Access Compliance Report Public Rights-of-Way (Curb Ramps)

Main Street: **RODEO_DR** Cross Street: **HARLE_AVE** Location: **NE**

ADA ID: **RPRK210922110128** Ramp Type: **Type 1 - Perpendicular Diagonal Initial Pass/Fail: Fail** Overall Compliance: **No** Severity Score: **2**

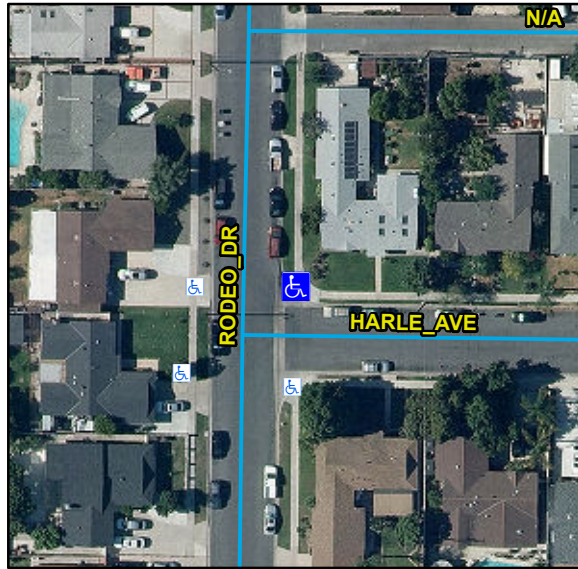
N/A	Ramp Inside Crosswalk 1	N/A	Yes	Ramp Inside Crosswalk 2	N/A
	Crossing 1 Slope (%)	5.6		Crossing 2 Slope (%)	1.8
	Crossing 1 Cross Slope (%)	0.6		Crossing 2 Cross Slope (%)	1.7
N/A	Gutter Ponding	No	No	Curb Slope	12
Yes	Gutter Lip Height (in)	0		Road Run Slope (%)	0.4
N/A	Gutter Run Slope (%)	1		Road Cross Slope (%)	0.3
N/A	Gutter Cross Slope (%)	0.7			
Yes	Overall Surface Condition: Acceptable		Yes	Perp Joint Present	Yes
	Cross Gutter Present?	Yes		Spandrel Present?	Yes
	Replace Cross Gutter?	No		Replace Spandrel?	No

Remove & Replace Curb Ramp With Two New Directional Ramps or Equivalent.
